IEEE P802.3at DTE power via MDI Enhancements Procedure for Conditional Approval to Forward a Draft Standard report

The following is the Clause 19 'Procedure for Conditional Approval to Forward a Draft Standard' report for IEEE P802.3at DTE power via MDI Enhancements which received conditional approval to proceed to sponsor ballot at the November 2008 IEEE 802 Plenary meeting.

Comment #15:

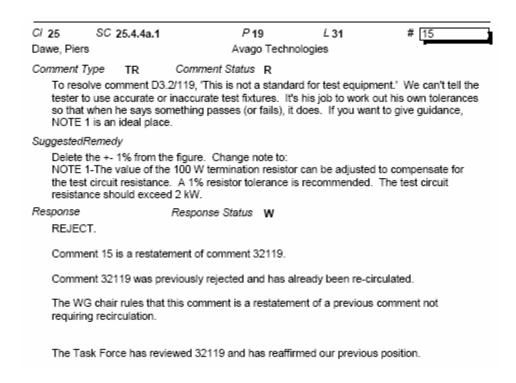
Two Technical Required comments were received from one existing DISAPPROVE voter. Verbatim copies of those comments and the detail rulings of the chair are provided below.

The WG chair rules this comment is a new invalid DISAPPROVE comment.
